14695 TRIADELPHIA MILL ROAD
ON-SITE SEWAGE DISPOSAL DESIGN PLAN
LOT 5

PLAT NO. 5960
TAX ID. 05-385431
MAP 27
ELECTION DISTRICT 4
HOWARD COUNTY, MARYLAND

After review of the OSDS plan here are my comments.

1500 GALLON TANK
Heavy Traffic Rated
Stock Item [Approx. Wt. - 16,000 lbs.]

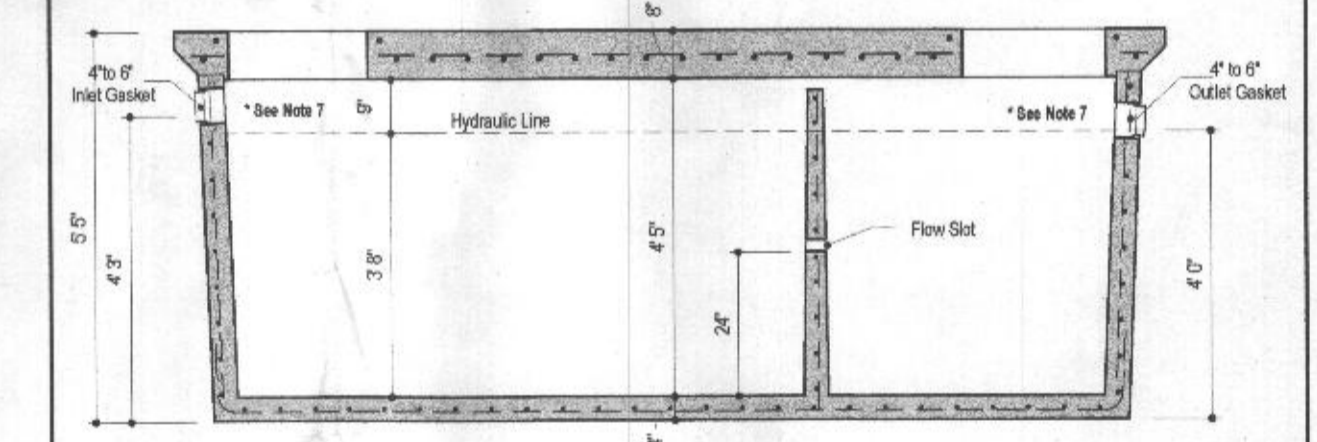
- ✓ 3. There needs to be a tank diagram on the plan. Need to see the size and measurements of the tank. This can be pulled straight from the manufactures specs as long as everything is clear and visible. Example attached. **This has been placed on the plan.**

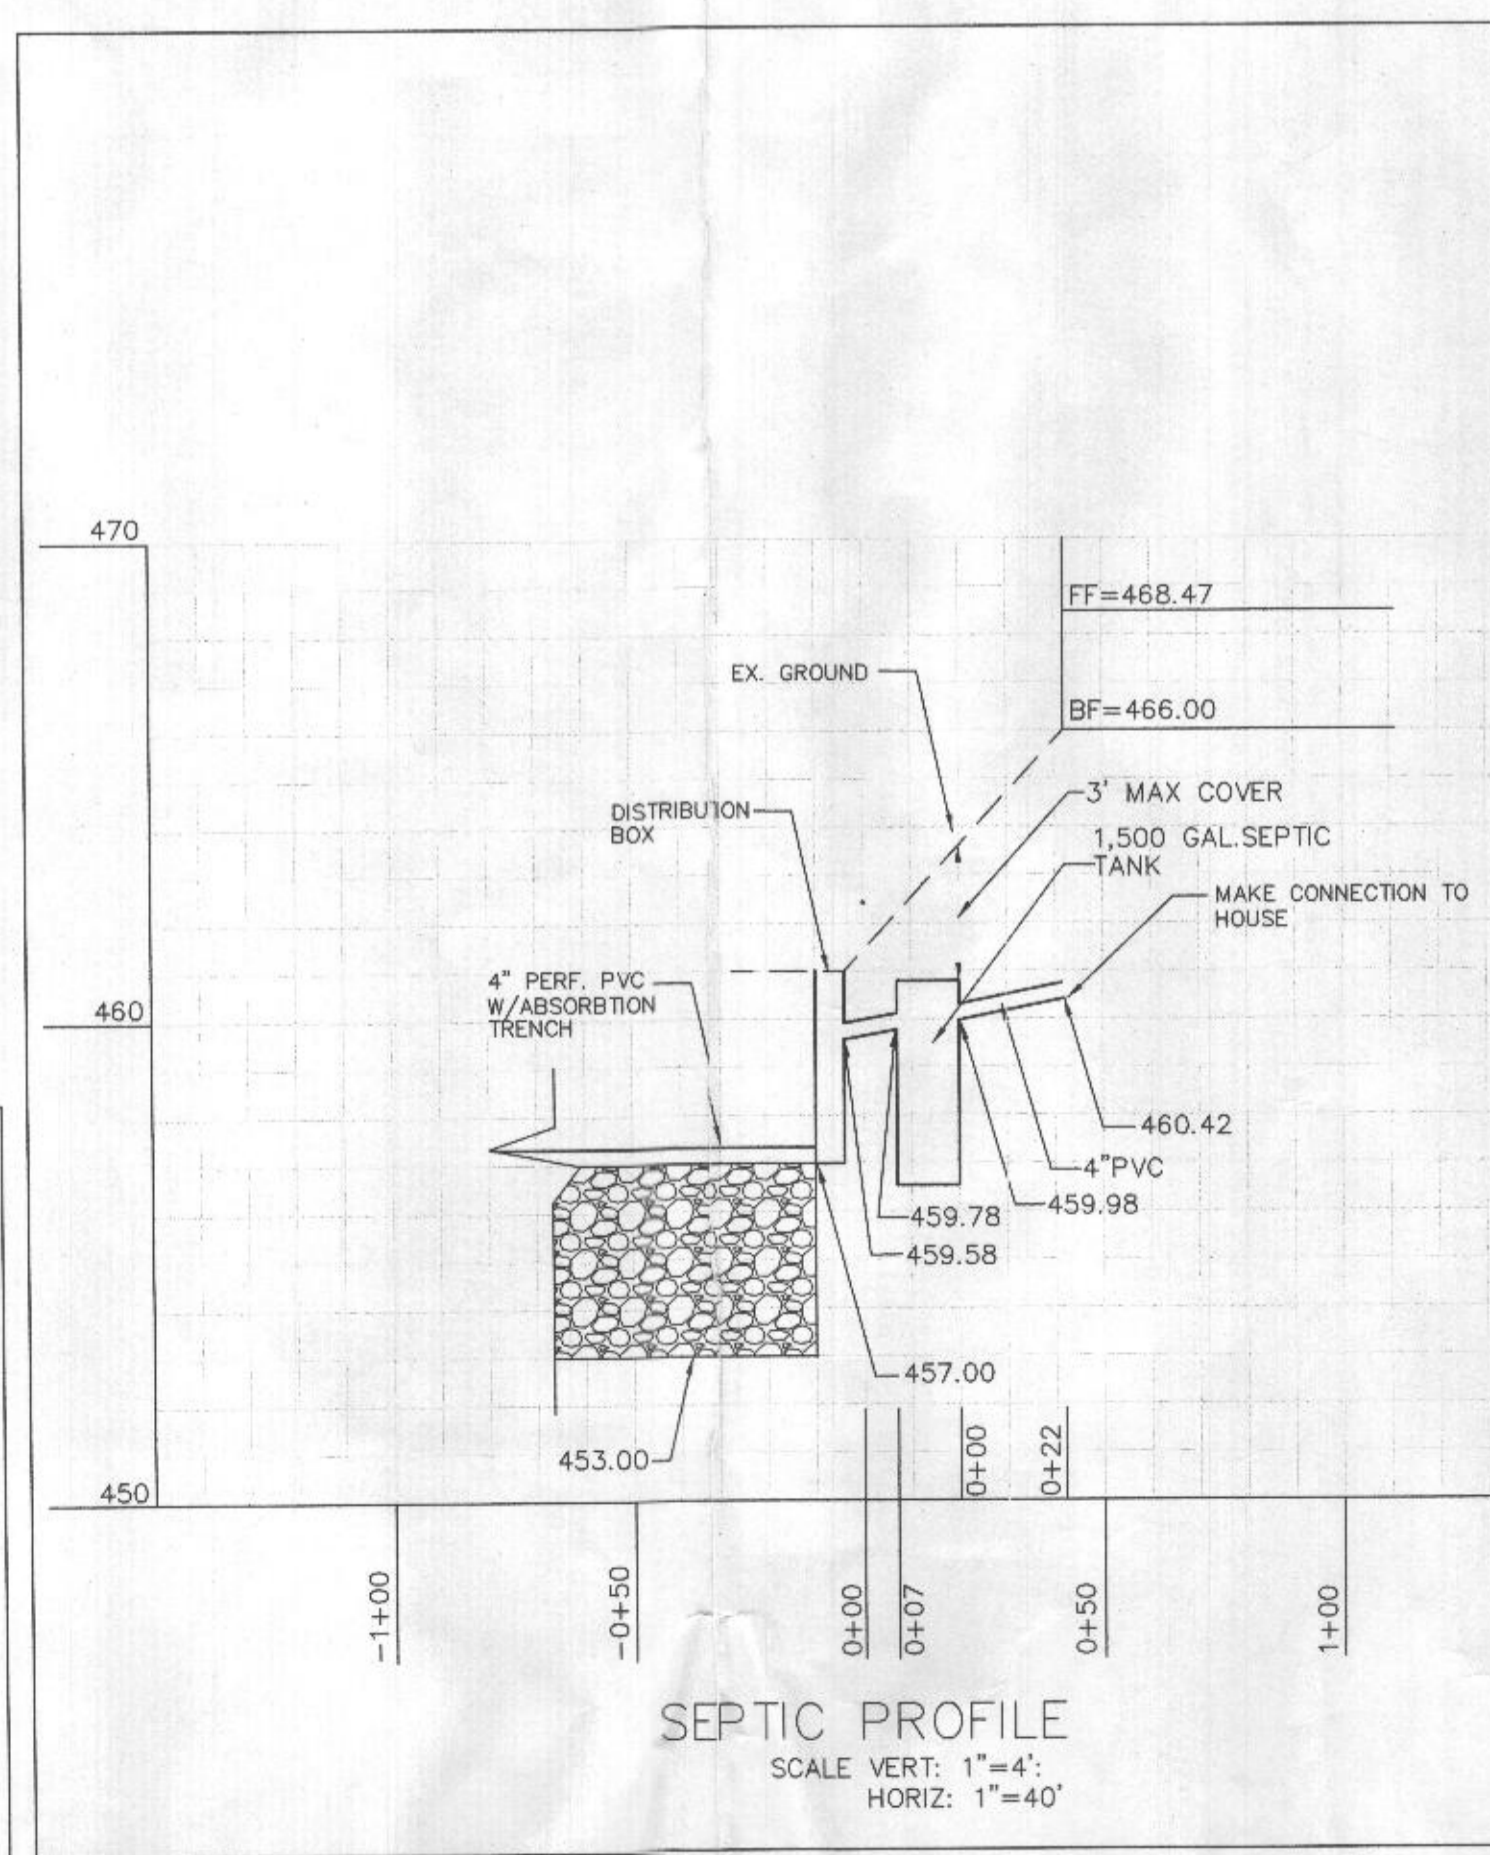
Here are my comments regarding the OSDS plan.

- ✓ 1. The plan needs to be to scale. The well arch shows 100ft but it measure 105ft. Other measurements are off as well. **I am not sure what print you had. Everything, per scale, checks out on my end, it may have been the print. I will make sure I am the one making the prints so the plan is true to scale.**

- ✗ 2. Show the sewage disposal area that was approved on the perc cert without the added label and subtracted portion. The total area that was approved on the perc is now the new revised area. No need to label the added areas or show the subtracted portions. **This has been corrected**

- ✗ 5. Septic profile needs to show elevation internals on the sides. **I am not sure what "elevation internals" means, can you possibly better explain what you need to see?**

SEPTIC TRENCH DETAIL (INITIAL AND FIRST REPLACEMENT)
(NOT TO SCALE)

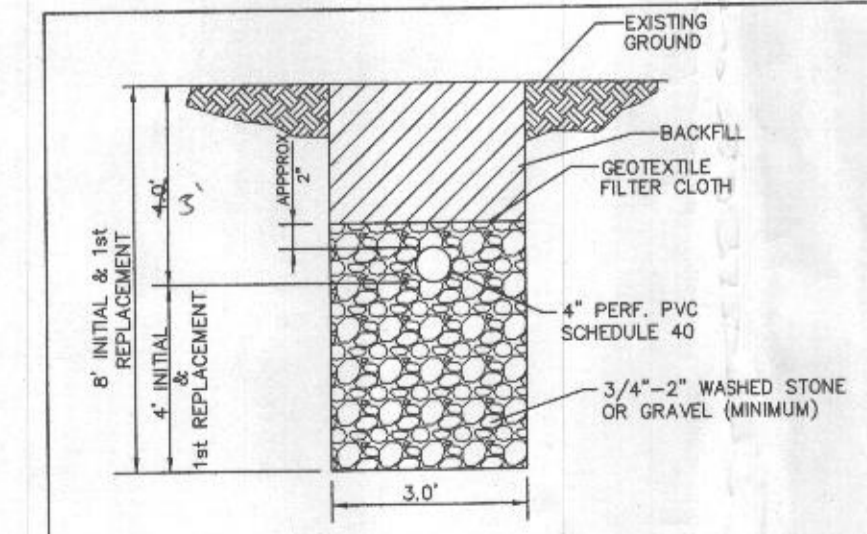
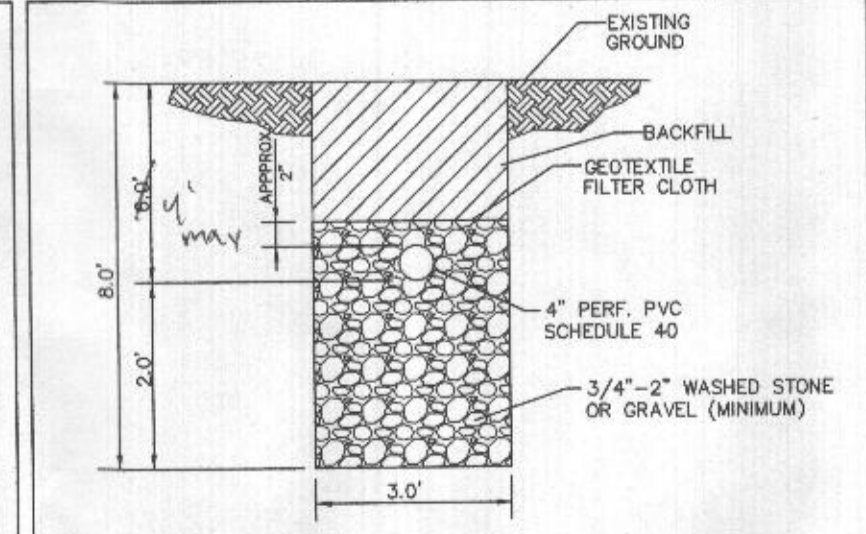
- ✓ 4. Needs a trench profile. Example attached. **This has been placed on the plan.**
